# JAMES BAY LITHIUM MINE PROJECT

## ANSWERS TO THE FOURTH INFORMATION REQUEST RECEIVED FROM THE MELCC AS PART OF THE ENVIRONMENTAL REVIEW OF THE PROJECT

GALAXY LITHIUM (CANADA) INC.

PROJECT NO.: 201-12362-00  
DATE: MARCH 2022

**Figure A-QC4-26-1 “k” Factor Distribution Curve with Particle Size**

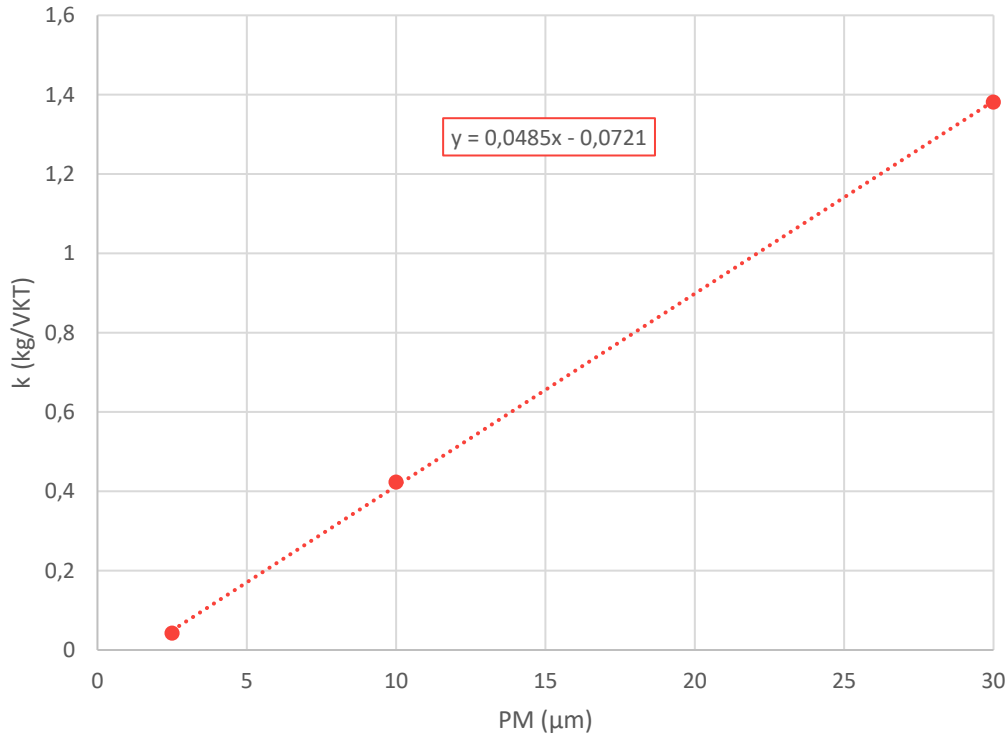
Fugitive dust PM<sub>4</sub> emissions from unpaved haulage roads were calculated by interpolating the "k" factor (kg/VKT) from the particle size distribution curve derived from the “k” factor values for PM<sub>2.5</sub>, PM<sub>10</sub> and TPM (US EPA AP-42 Chapter 13.2.2 Unpaved Roads), as described in the response to QC4-26.

Fugitive dust PM<sub>4</sub> emissions from unpaved haulage roads were calculated by interpolating the "k" factor (kg/VKT) from the “k” factor distribution curve derived from the “k” factor values for PM<sub>2.5</sub>, PM<sub>10</sub> and PM<sub>30</sub> (US EPA AP-42 Chapter 13.2.2 Unpaved Roads). The “k” factors for PM<sub>2.5</sub>, PM<sub>10</sub> and PM<sub>30</sub> from the US EPA AP-42 Chapter 13.2.2 are provided in Table A-QC4-26-1 below. The derived “k” factor distribution curve based on the “k” values in Table A-QC4-26-1 is shown in Figure A-QC4-26-1 below. The “k” factor for PM<sub>4</sub> was interpolated from the “k” factor distribution curve resulting in a value of 0.1219 kg/VKT.

PM (µm)	k (lb/VMT)	k (kg/VKT)
PM <sub>2.5</sub>	0.15	0.0423
PM <sub>10</sub>	1.5	0.4228
PM <sub>30</sub>	4.9	1.3813

**Table A-QC4-53 Summary of control and exposed sediment sampling stations**

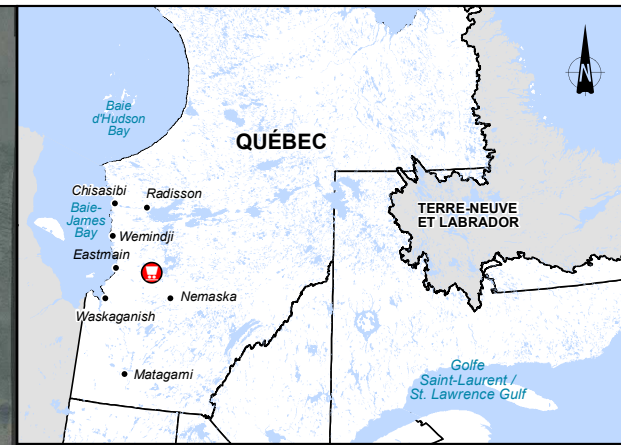
In the document *Complément à l'étude spécialisée sur l'habitat aquatique – Caractérisation des sédiments à deux stations supplémentaires* (WSP, 2021) the proponent presents the initial characterization of the sediments which was carried out at two additional stations of the CE-2 watercourse (document PN-4.26). These are the two stations CE-2C and CE-2D, both located downstream of the mine discharge in the CE-2 watercourse. Questions QC4-53 to QC4-59 relate to the aforementioned document.

Map RQC4-53 shows the location of all sampling stations. It shows that most stations are located along watercourses and not in lakes or steep meanders. It is important to note that the stations were located in areas where there is sufficient sediment accumulation to allow for the collection of five samples (substations). However, the location of some stations was based on the accessibility (often difficult) of watercourses. The accessibility to the stations, for the construction and operation follow-up campaigns, should be improved once the mine site is built. Also, some watercourses had very few areas of sediment accumulation in addition to being mainly composed of an organic substrate. Table A-QC4-53 provides a brief description of the control and exposed sampling stations.

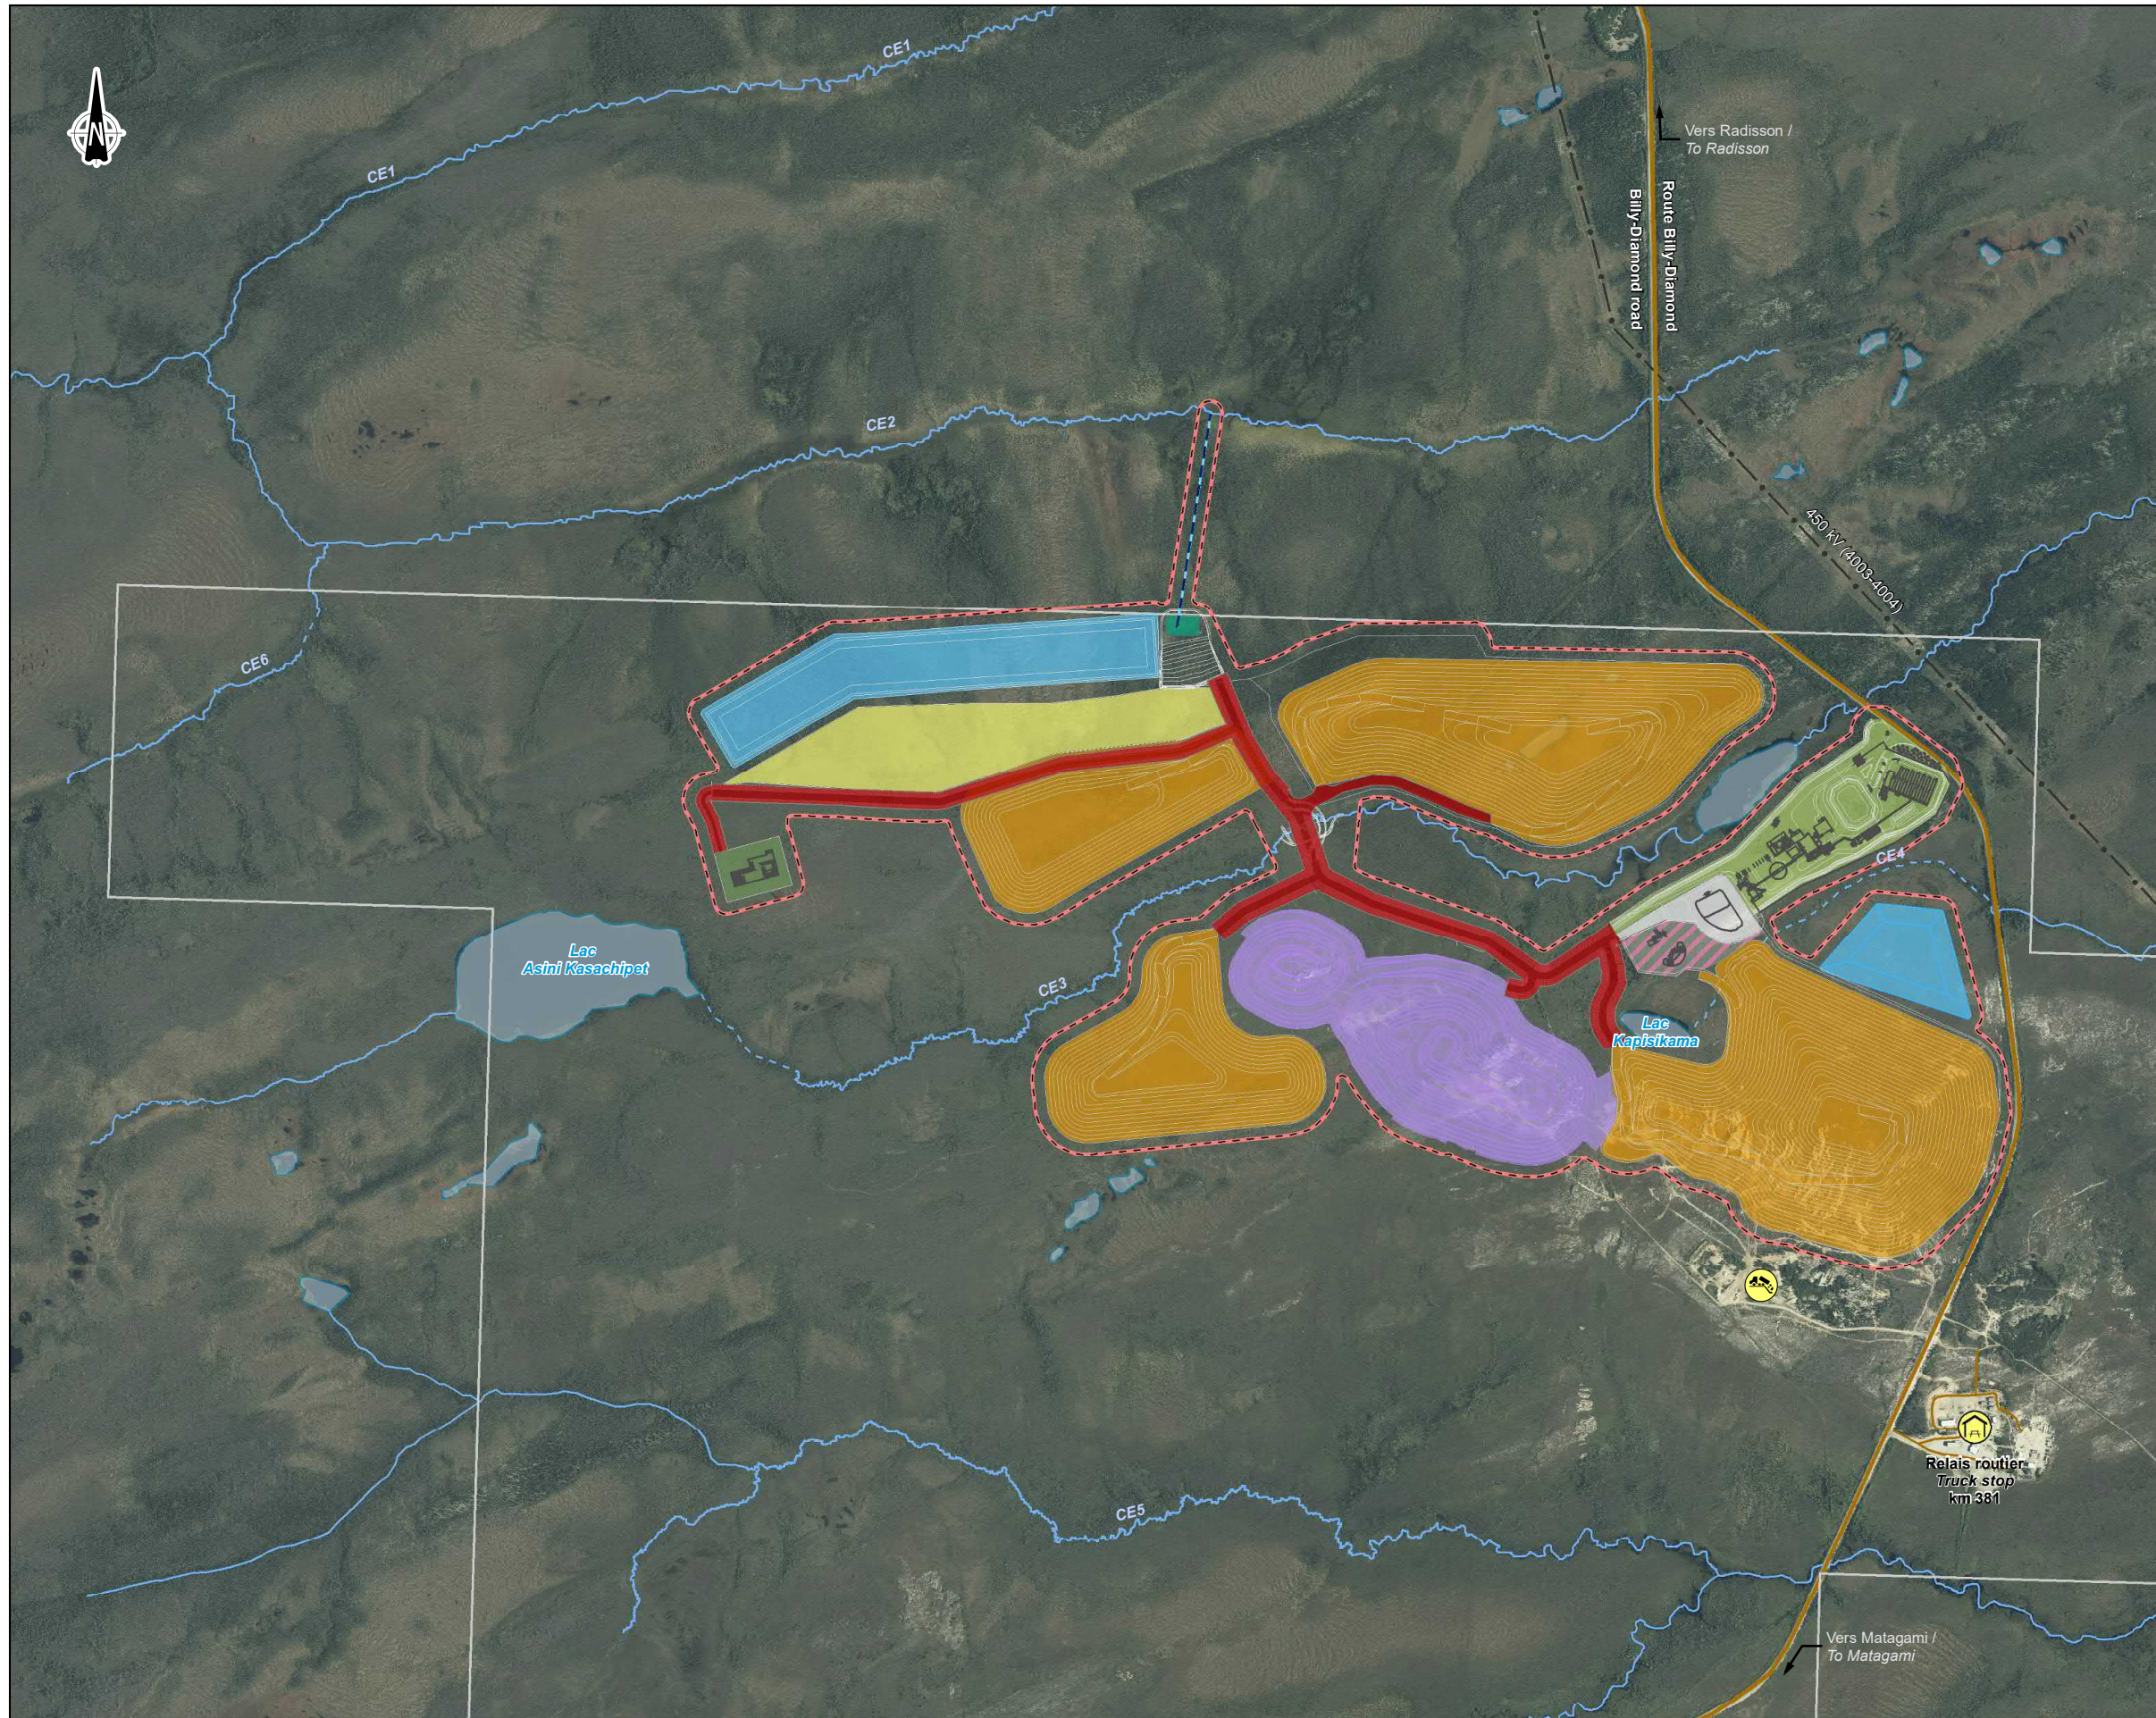
<b>QC4-70</b>	<b>The proponent must specify whether one or more users of the territory have indicated that they wish their camp to be moved because of the project.</b>
---------------	---

As part of the many consultations and exchanges with users of the territory, none mentioned that they wanted their camp to be moved because of the project.
